JTB00552NAS7

TECHNICAL BULLETIN

This reissue replaces all previous versions. Please destroy all previous versions.

InControl® Touch Pro™ Features May Not Function As Expected

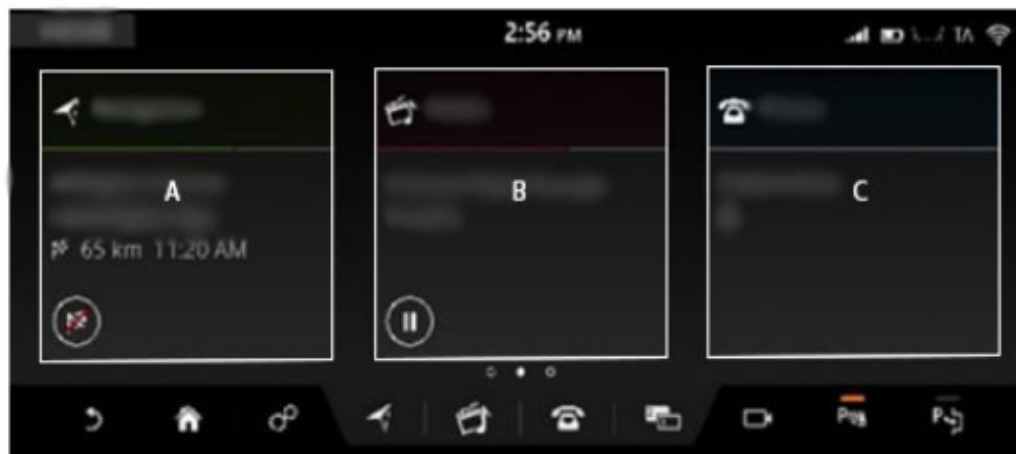
The look and feel of the single-screen InControl® Touch Pro™ system will, if not already updated with Phase 4 '18B' software, change to match that of the InControl® Touch Pro Duo™ system. When this software update is finished, it **CANNOT** be reversed. Refer to the latest InControl Touch Pro Release Notes on TOPIx for more information.

Vehicles with Single-Screen System current 4-tile home screen:

- **A** - Media
- **B** - Climate
- **C** - Phone
- **D** - Navigation

Vehicles with Single-Screen System updated 3-tile home screen:

- A - Navigation
- B - Media
- C - Phone
